Access Compliance Report

Public Rights-of-Way

Intersection ID: 51071	Main Street: KEMPSFORD_DR	Cross Street: GRICKLADE_DR	Location: NE
ADA ID: 5D13516305AF	Ramp Type: Perp	Initial Pass/Fail: Fail	Overall Compliance: No
Codes/Mitigation Info/Possible Solution		Field Measurements/Component Compliance	
Severity Score: 26.25

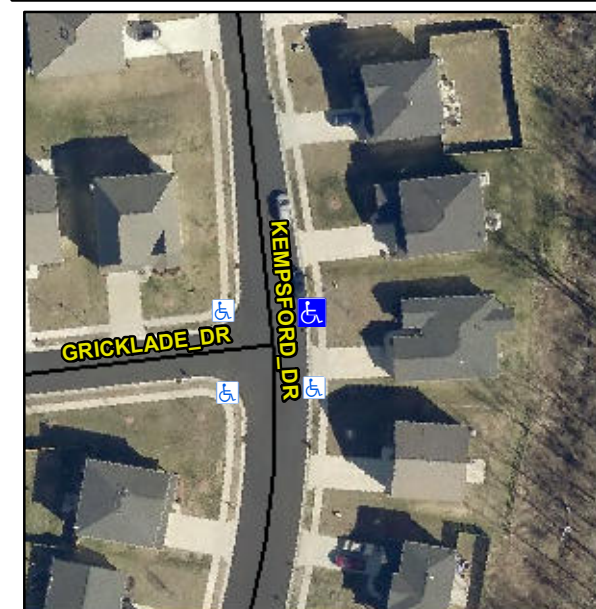
Not Found, R304.2.2, R304.5.3

Compliance	Description	Data	Compliance	Description	Data
N/A	Ramp Length (in)	51.0	No	Ramp Slope (%)	12.0
Yes	Ramp Width (in)	48.0	No	Ramp XSlope (%)	3.3
N/A	Flare Type LT	N/A	N/A	Flare Type RT	N/A
N/A	Flare Slope LT (%)	N/A	N/A	Flare Slope RT (%)	N/A
N/A	Flare Traversable LT?	N/A	N/A	Flare Traversable RT?	N/A
N/A	Landing Length (in)	N/A	N/A	DWS Provided?	N/A
N/A	Landing Width (in)	N/A	N/A	DWS Contrast?	N/A
N/A	Landing Slope (%)	N/A	N/A	DWS Length (in)	N/A
N/A	Landing X Slope (%)	N/A	N/A	DWS Full Width?	N/A
N/A	Landing Curb? (Y/N)	N/A	N/A	DWS Offset (in)	N/A
N/A	Shared Landing?	N/A			
N/A	Gutter Ponding?	N/A	N/A	Gutter Slope (%)	N/A
N/A	Gutter Lip Ht (in)	N/A	N/A	Gutter X Slope (%)	N/A
N/A	Painted X Walk1?	No	N/A	Painted X Walk2?	N/A
	X Walk 1 Direction	To W		X Walk 2 Direction	N/A
N/A	X Walk 1 Width (in)	N/A	N/A	X Walk 2 Width (in)	N/A
	X Walk 1 Slope (%)	4.0		X Walk 2 Slope (%)	N/A
	X Walk 1 X Slope (%)	3.0		X Walk 2 X Slope (%)	N/A

Remove & Replace Entire Ramp.
